HURRICANE CITY UTAH

Hurricane Planning Commission Meeting Agenda

July 25, 2024
5:00 PM

Current: Single Family, Mixed Use,
Commercial
Change: Planned Community

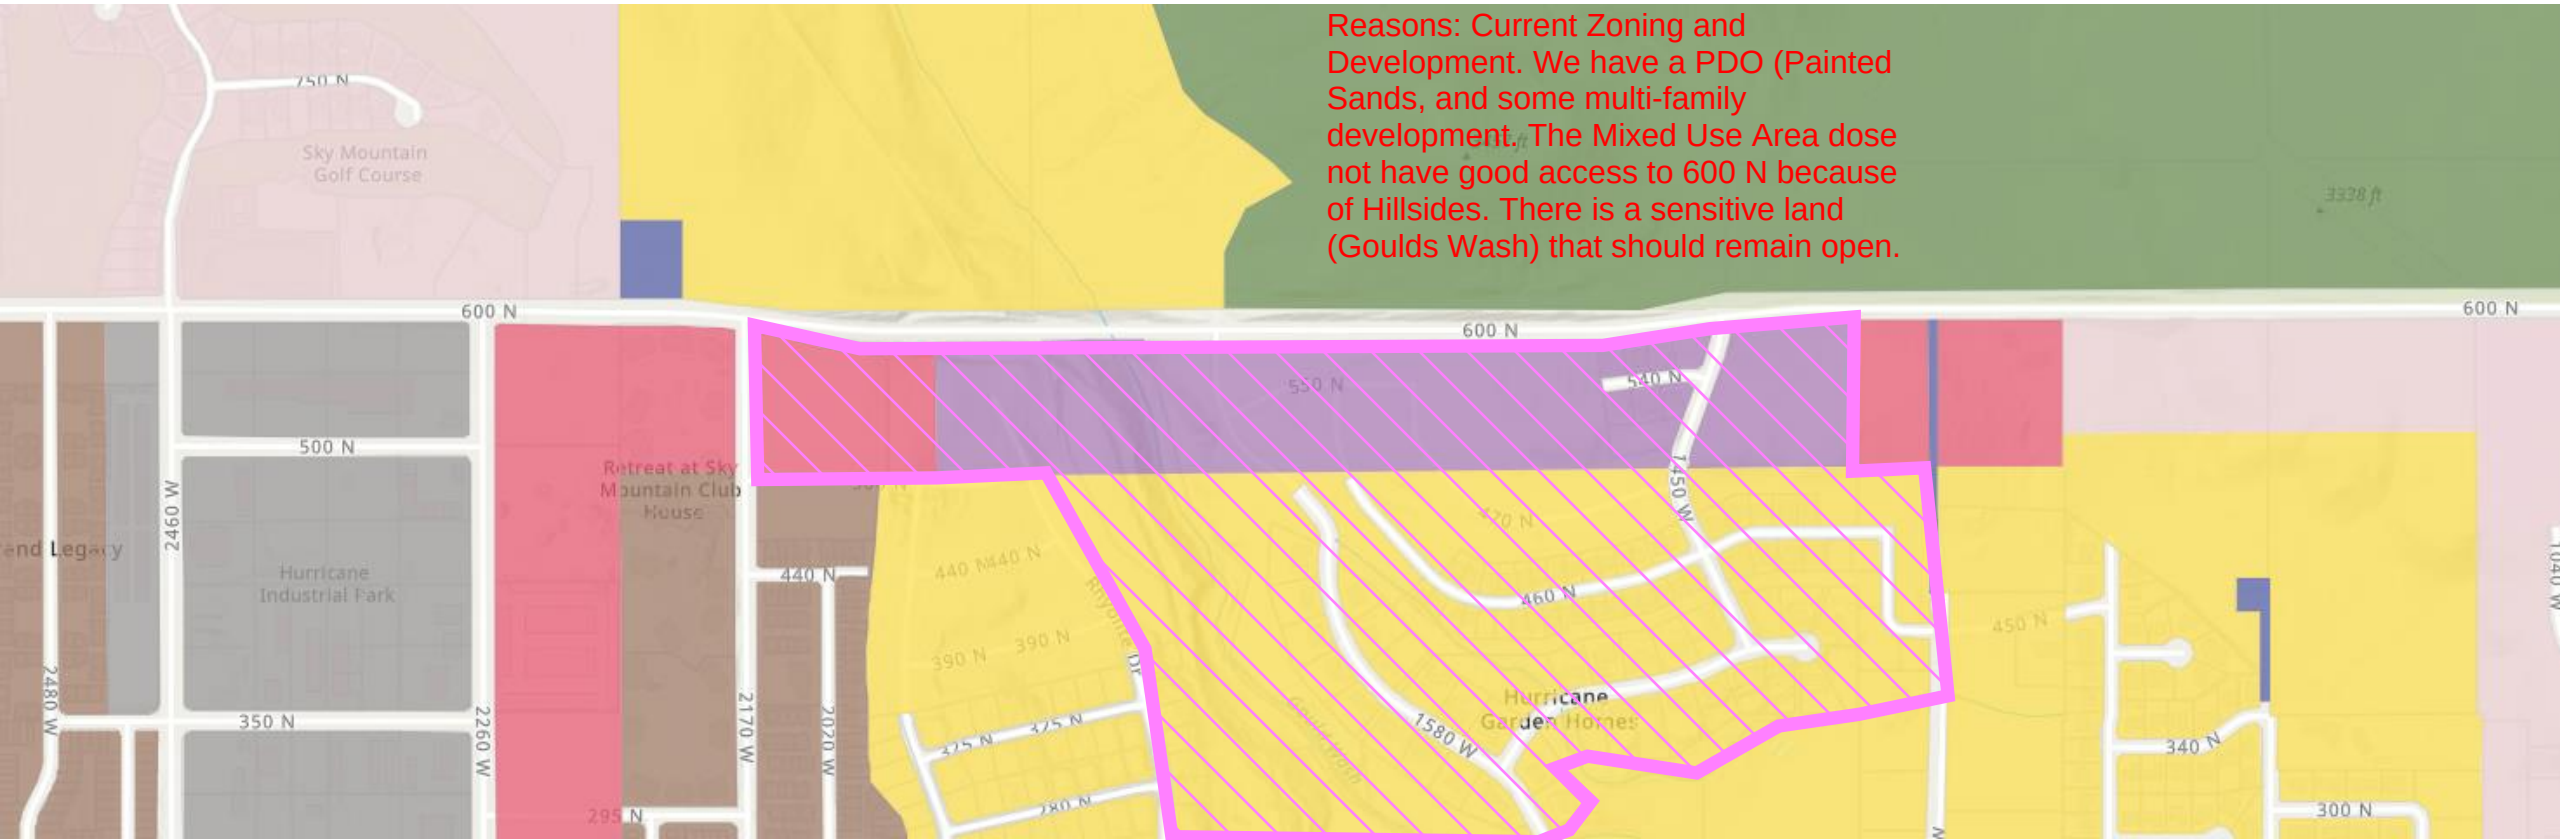
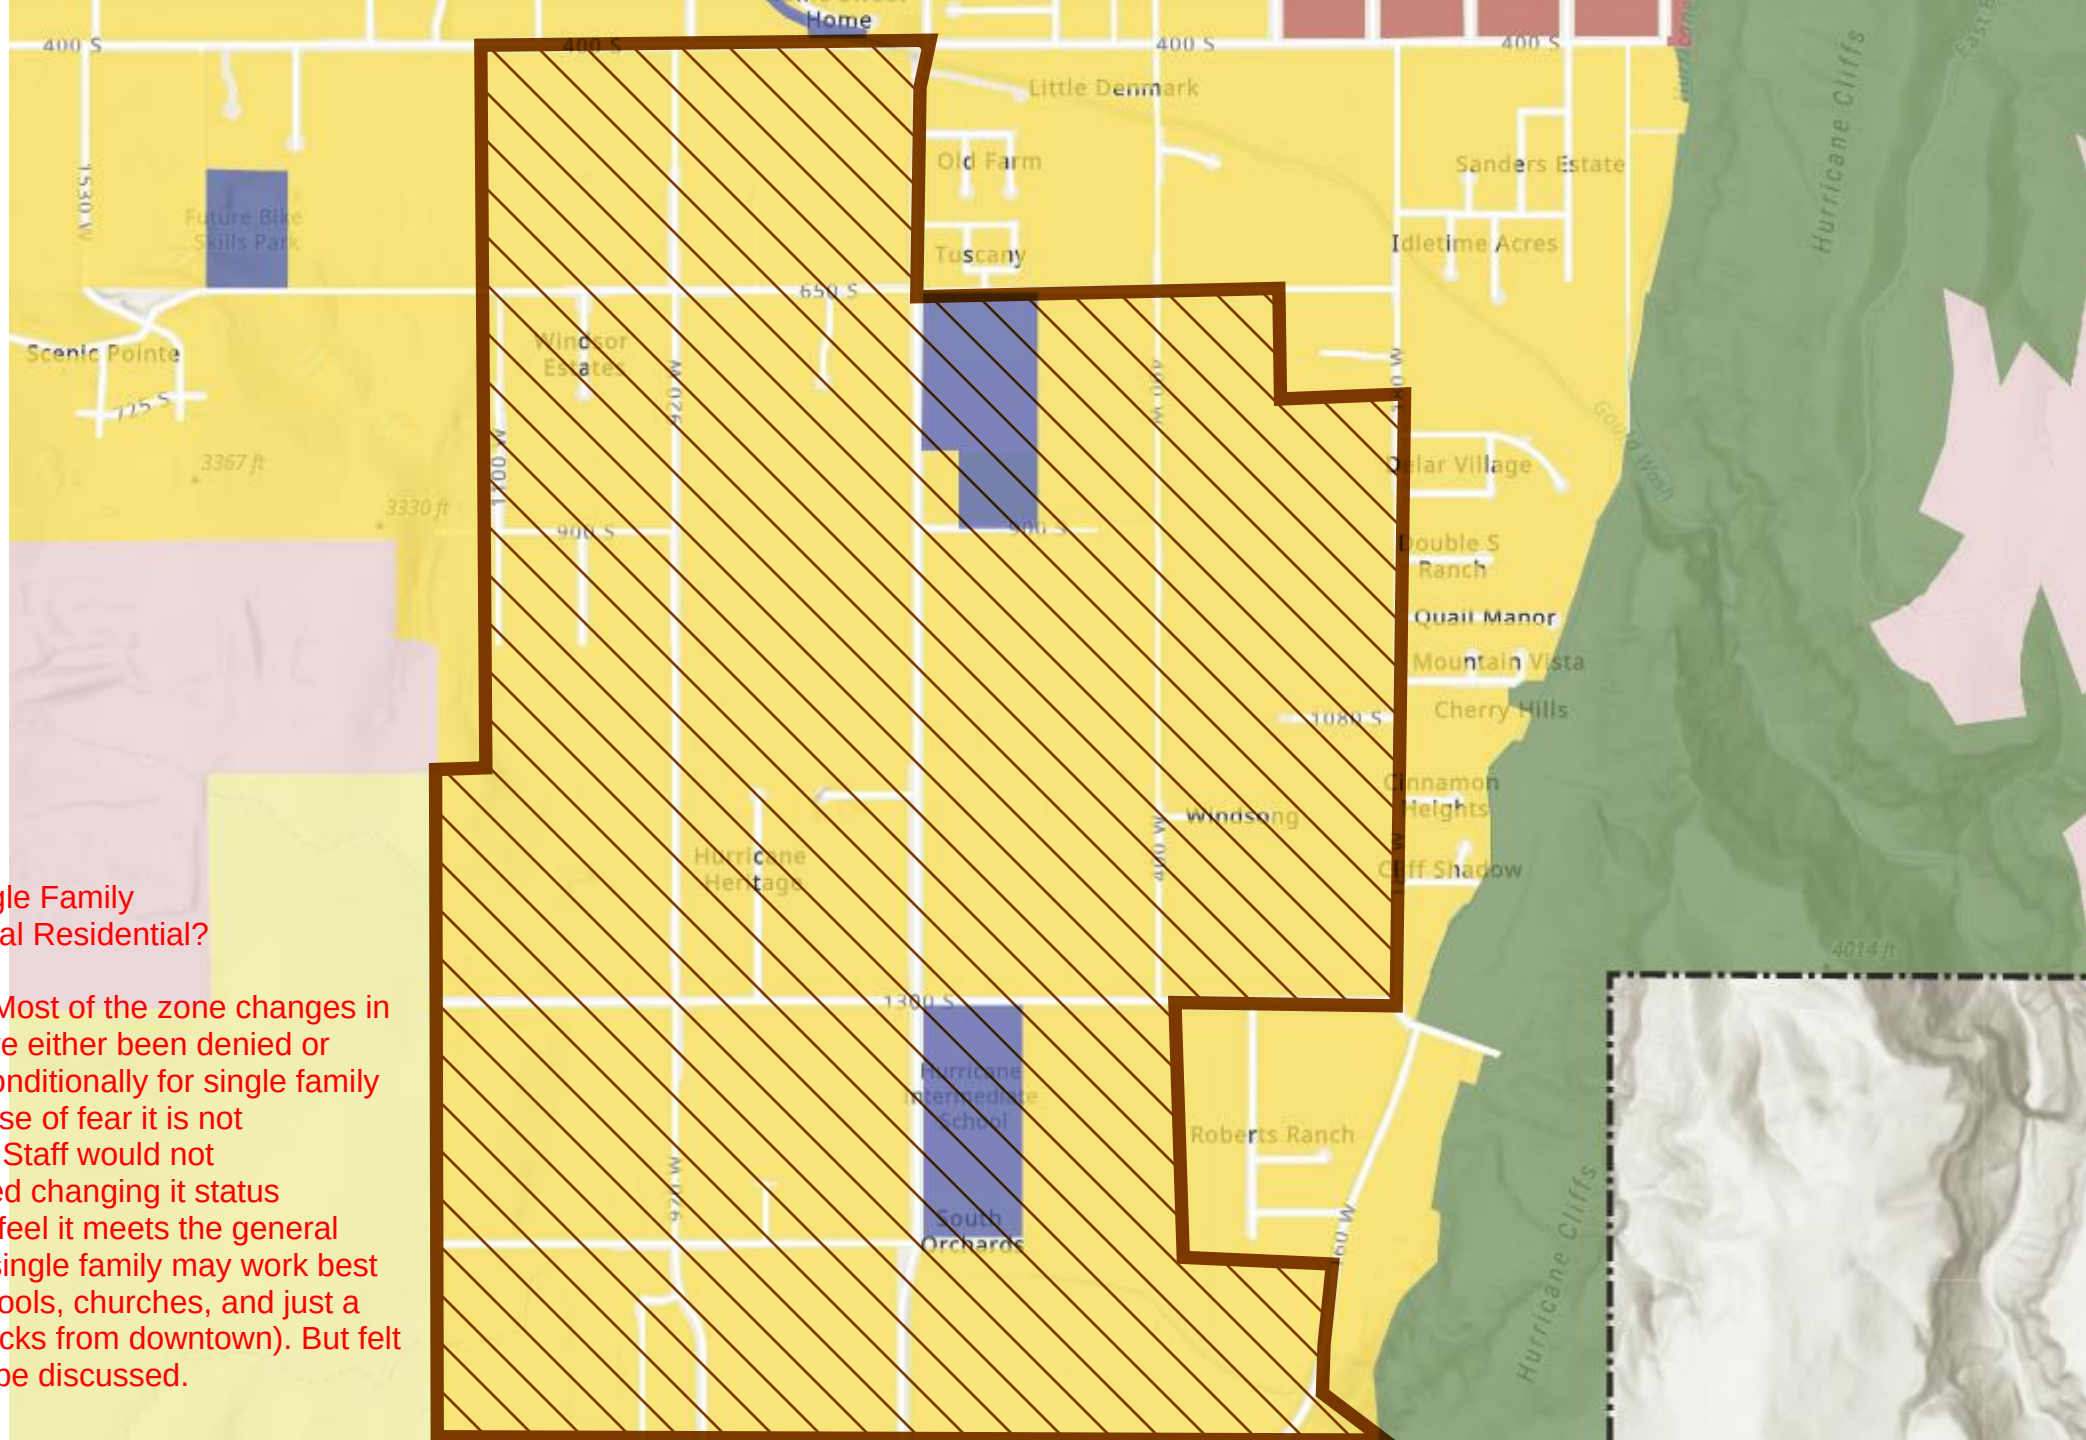
Reasons: Current Zoning and
Development. We have a PDO (Painted
Sands), and some multi-family
development. The Mixed Use Area dose
not have good access to 600 N because
of Hillsides. There is a sensitive land
(Goulds Wash) that should remain open.

Current: Single Family
Change: Rural Residential?

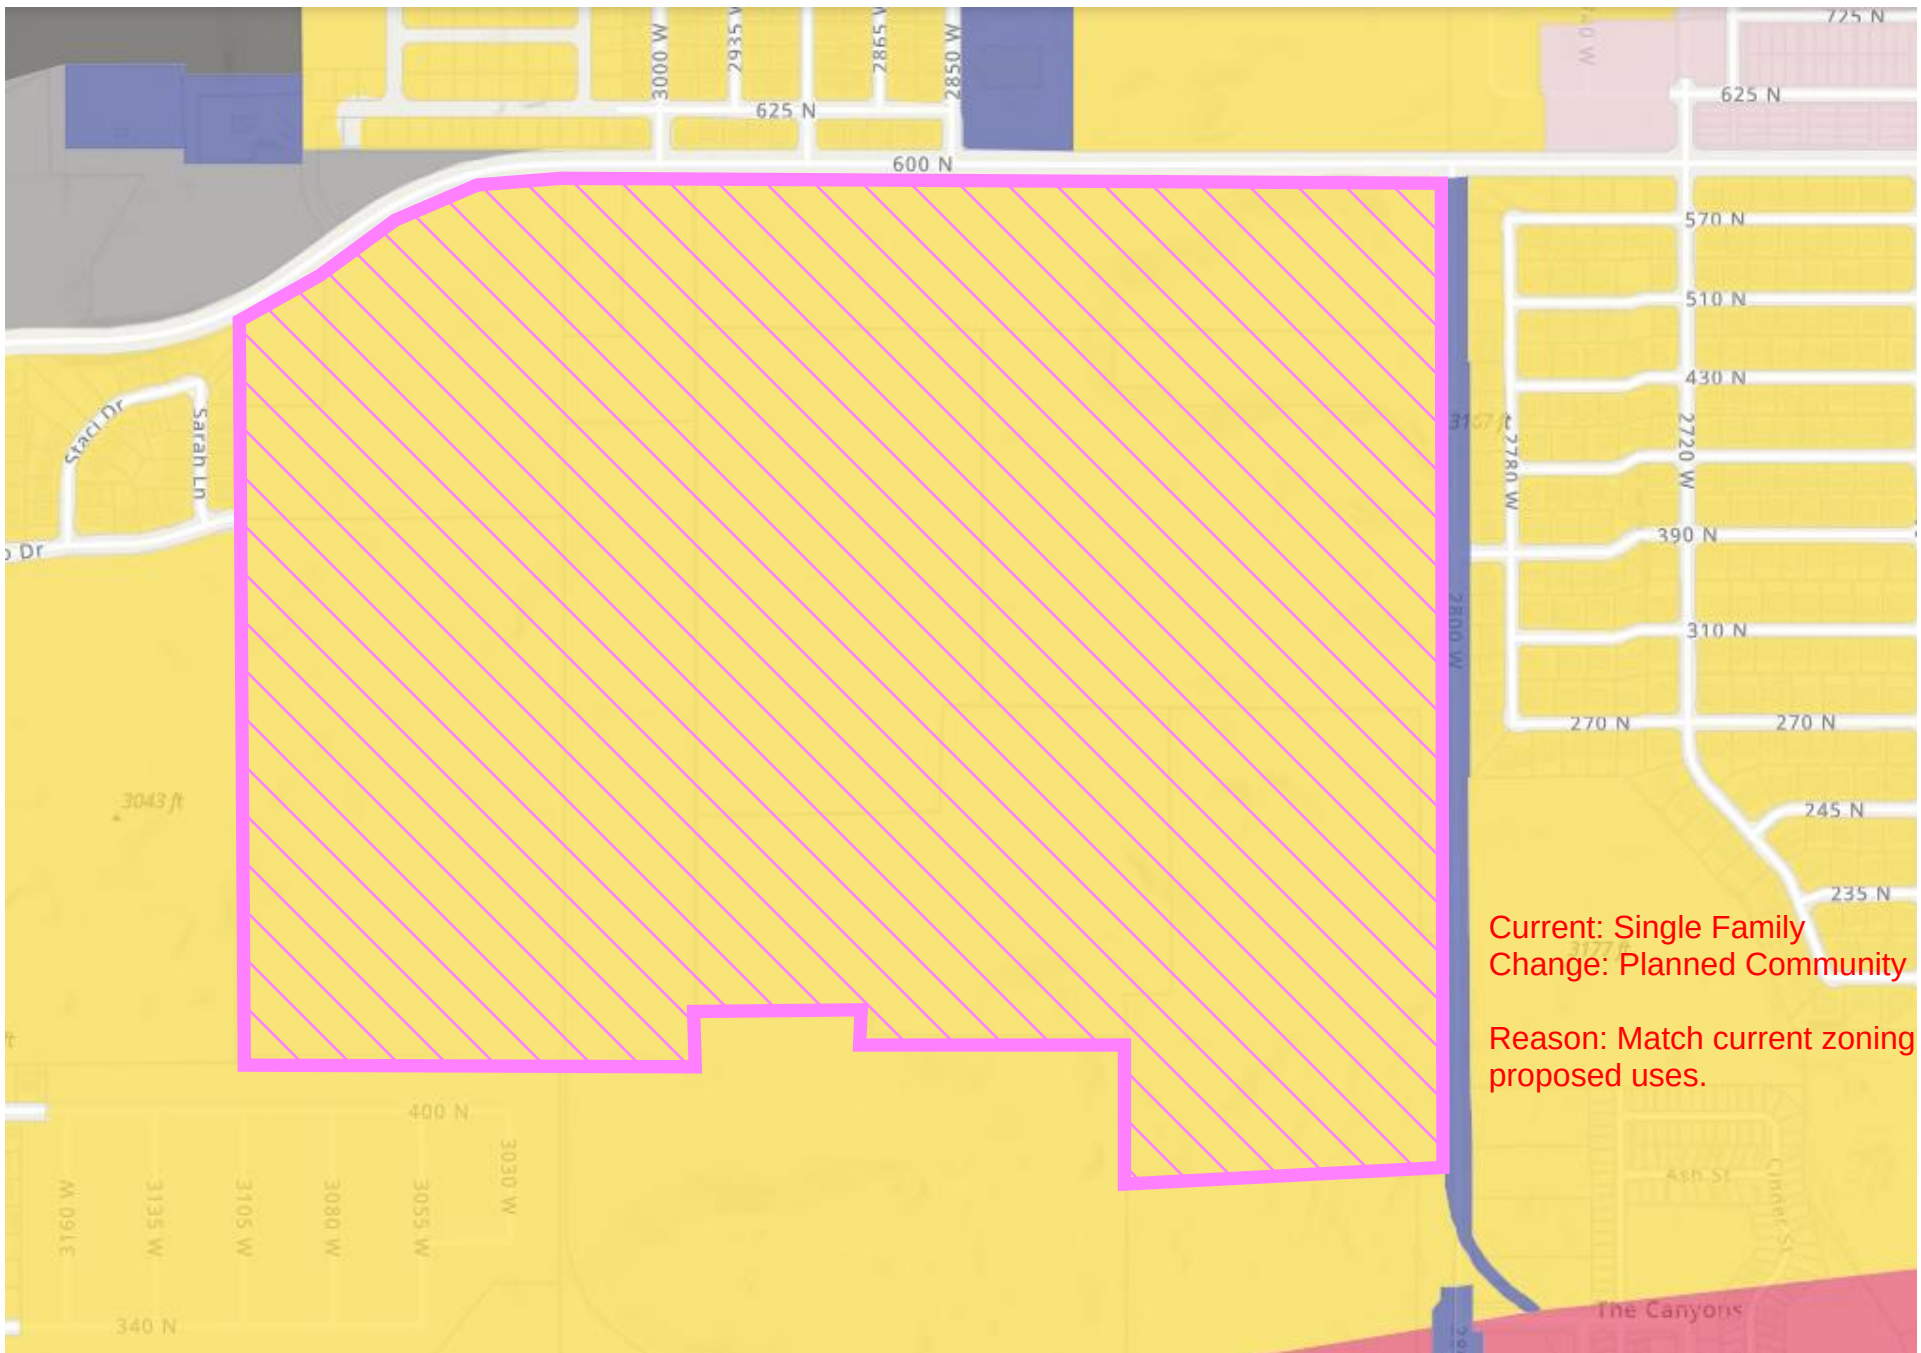
Discussion: Most of the zone changes in this area have either been denied or given very conditionally for single family zones because of fear it is not harmonious. Staff would not recommended changing it status because we feel it meets the general area where single family may work best (close to schools, churches, and just a couple of blocks from downtown). But felt it needed to be discussed.
